SUNDRY NOTICES AND REPORTS ON WELLS (DO NOT USE THIS FORM FOR PROPOSALS TO DRILL OR TO DEEPEN OR PLUG BACK TO A DIFFERENT RESERVOIR. USE "APPLICATION FOR PERMIT" (FORM C-101) FOR SUCH PROPOSALS.)		WELL API NO.
1. Type of Well: Oil Well ☐ Gas Well ☐ Other ☐		5. Indicate Type of Lease STATE ☐ FEE ☐
2. Name of Operator		6. State Oil & Gas Lease No.
3. Address of Operator		7. Lease Name or Unit Agreement Name
4. Well Location Unit Letter _____: _____ feet from the _____ line and _____ feet from the _____ line Section _____ Township _____ Range _____ NMPM _____ County _____		8. Well Number
11. Elevation (Show whether DR, RKB, RT, GR, etc.)		9. OGRID Number
		10. Pool name or Wildcat

1 API Number 30-015-50007		2 Pool Code 98220		3 Pool Name Purple Sage; Wolfcamp (Gas)	
4 Property Code 329348		5 Property Name POTATO BABY STATE COM			6 Well Number 906H
7 OGRID No. 229137		8 Operator Name COG OPERATING LLC			9 Elevation 3072.49'

POTATO BABY STATE COM #906H

Operator: COG OPERATING LLC 600 W Illinois Ave Midland, TX 79701	OGRID: 229137
	Action Number: 181975
	Action Type: [C-103] NOI Change of Plans (C-103A)

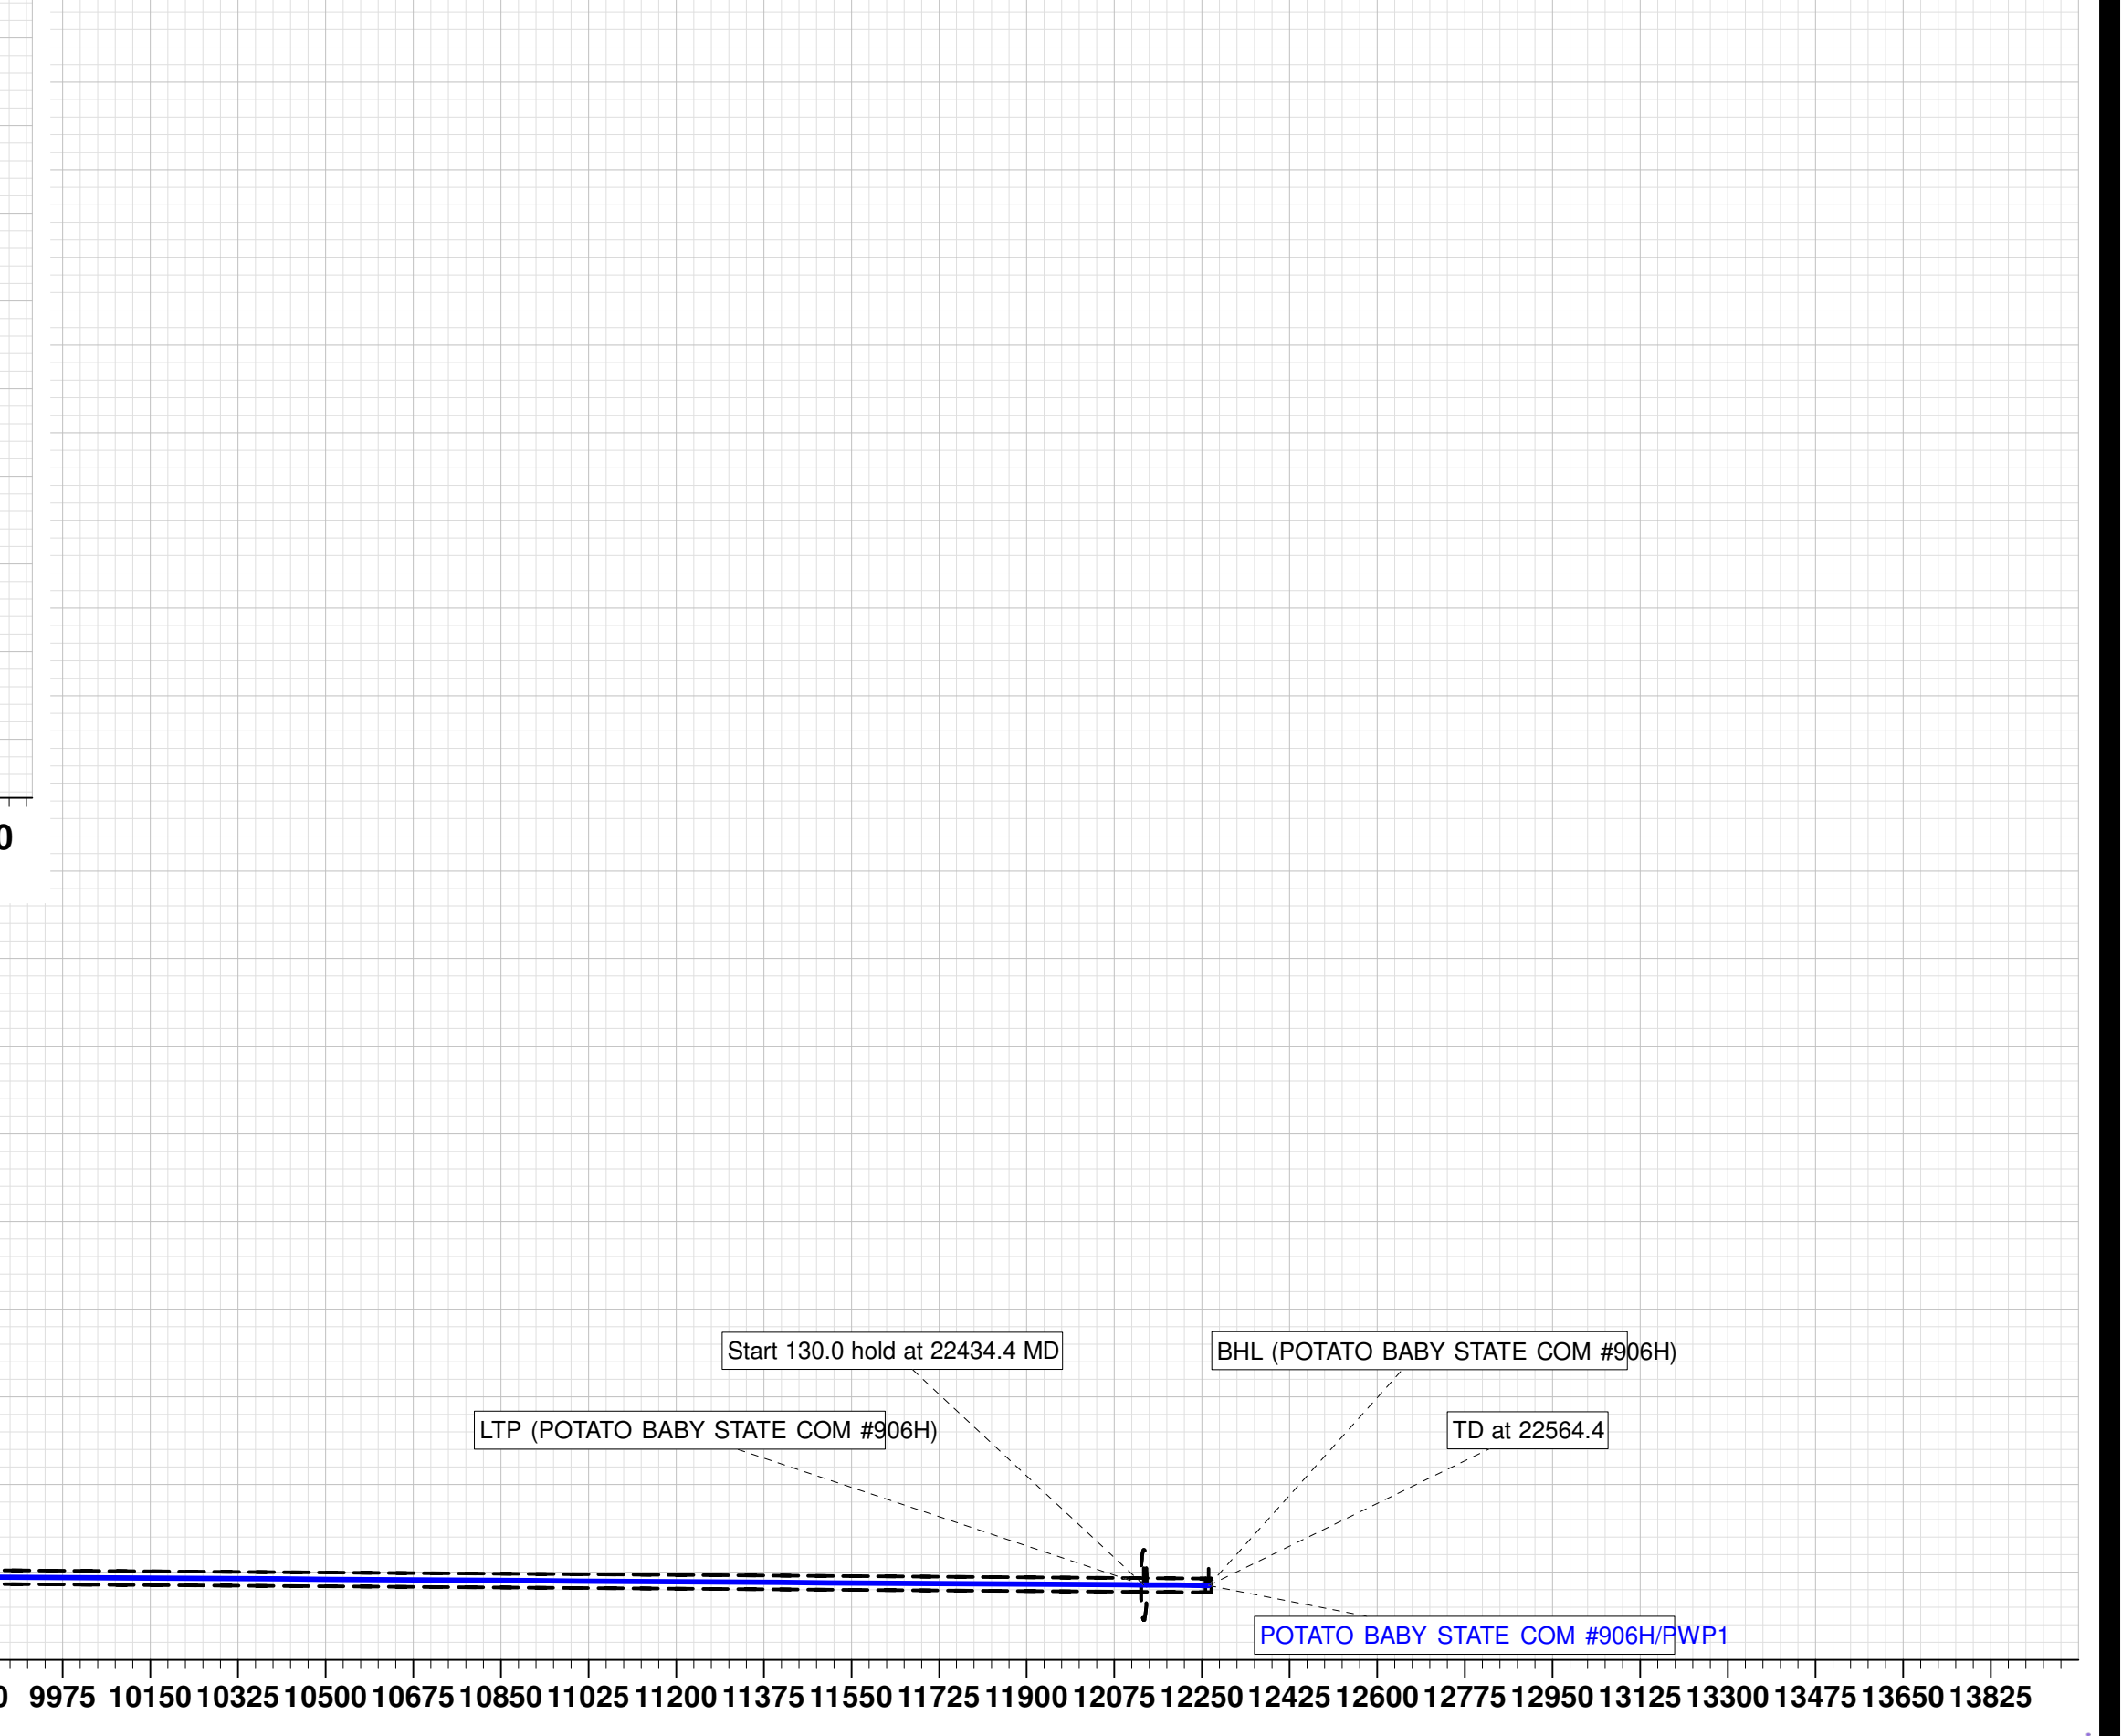
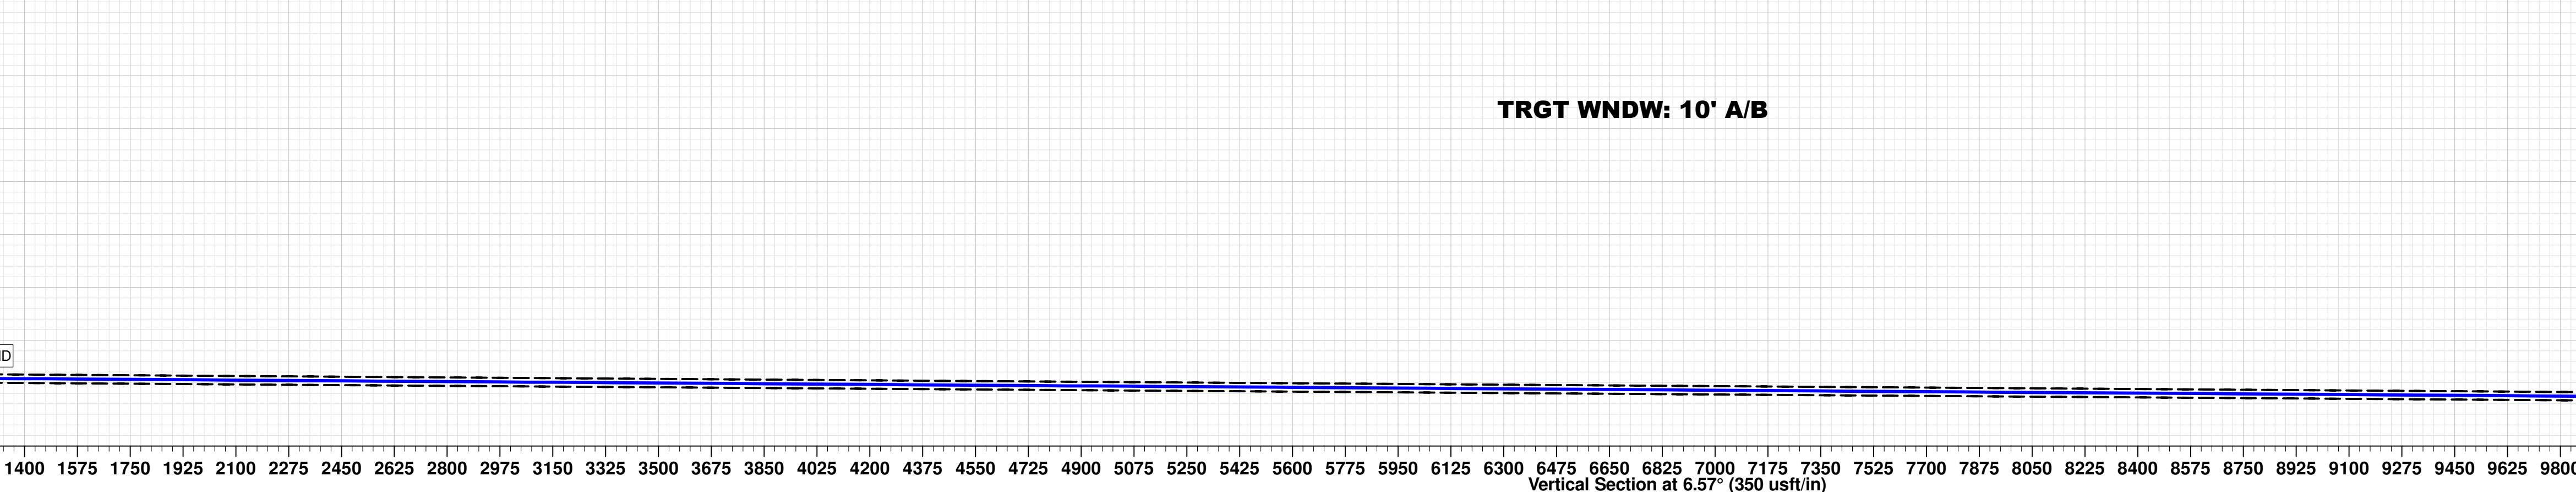
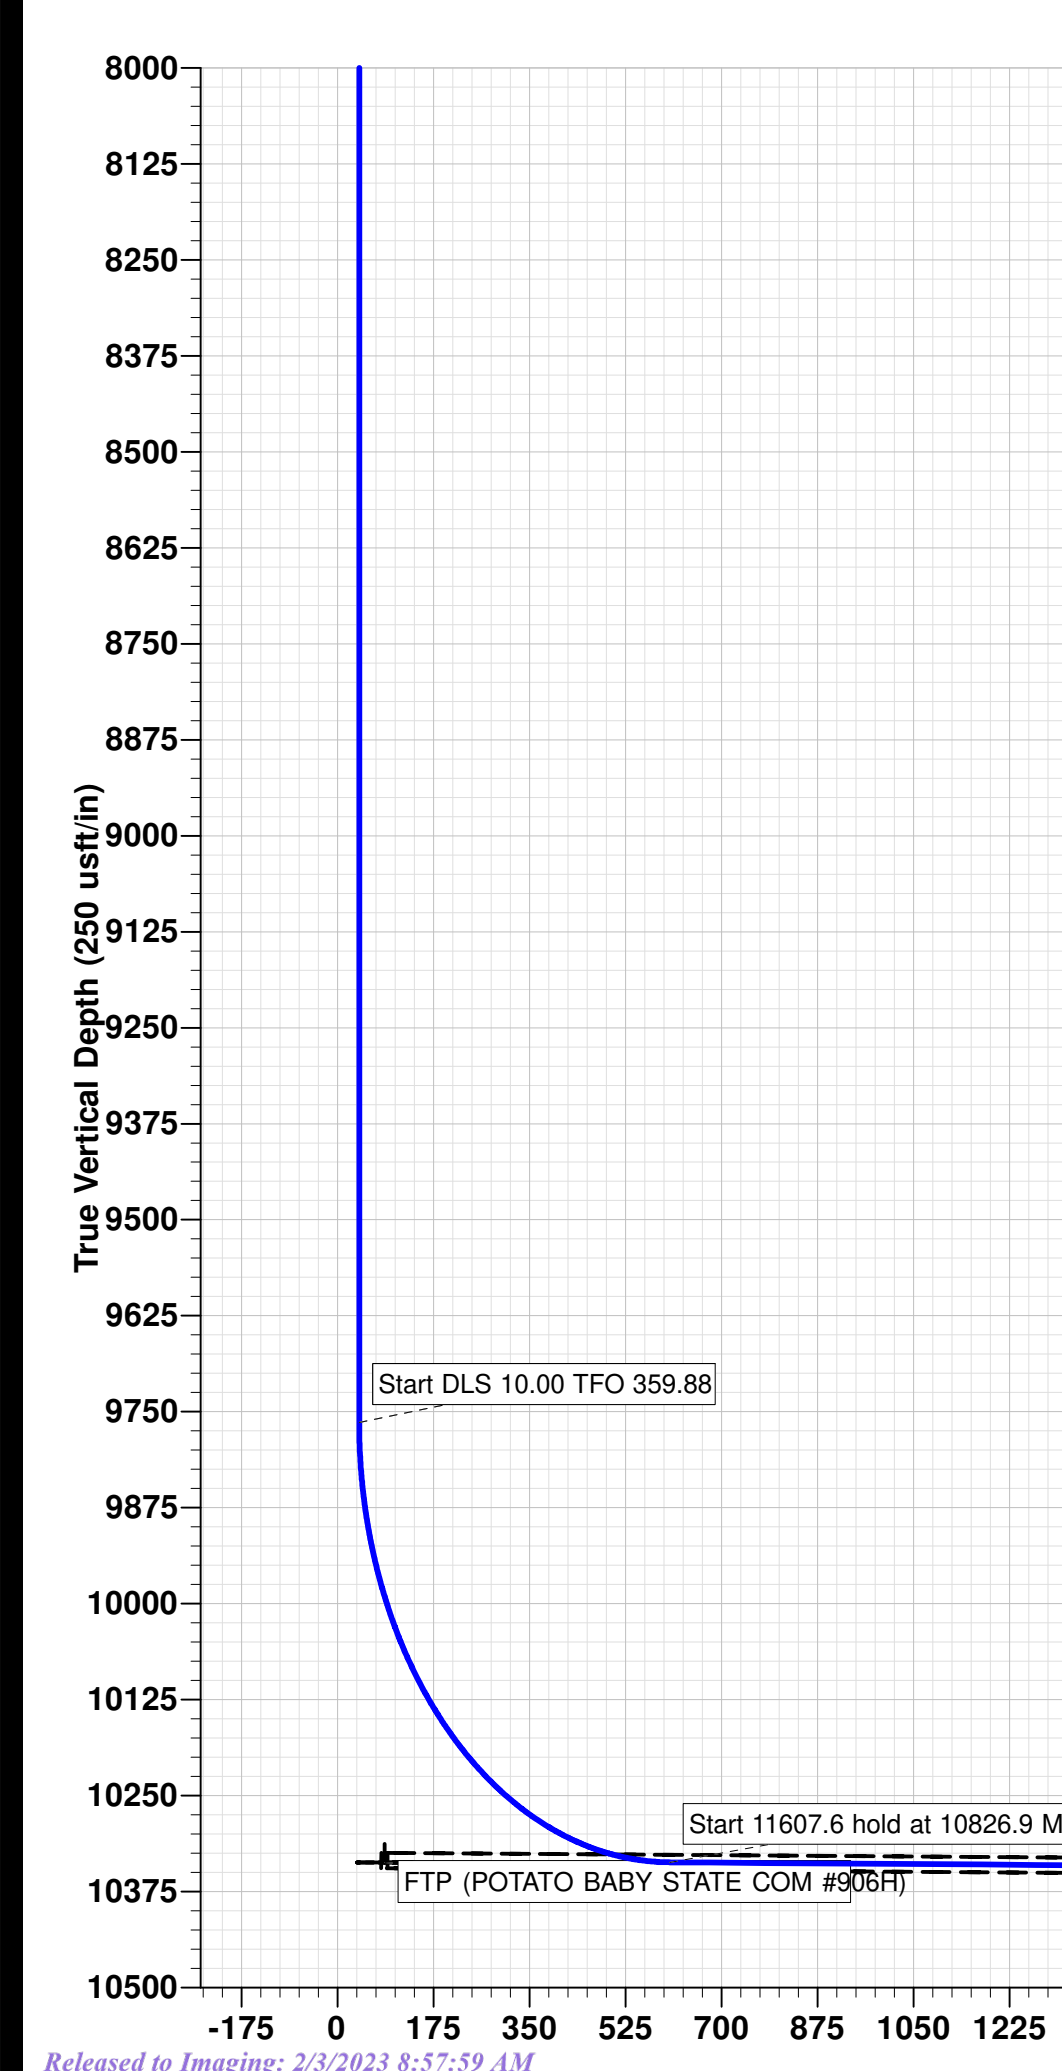
NOTICE OF INTENTION TO:		SUBSEQUENT REPORT OF:	
PERFORM REMEDIAL WORK ☐	PLUG AND ABANDON ☐	REMEDIAL WORK ☐	ALTERING CASING ☐
TEMPORARILY ABANDON ☐	CHANGE PLANS ☐	COMMENCE DRILLING OPNS. ☐	P AND A ☐
PULL OR ALTER CASING ☐	MULTIPLE COMPL ☐	CASING/CEMENT JOB ☐	
DOWNHOLE COMMINGLE ☐			
CLOSED-LOOP SYSTEM ☐			
OTHER: ☐	Change BHL ☒	OTHER: ☐

UL or lot no.	Section	Township	Range	Lot Idn	Feet from the	North/South line	Feet from the	East/West line	County
C	22	26-S	28-E		200'	NORTH	2245'	WEST	EDDY
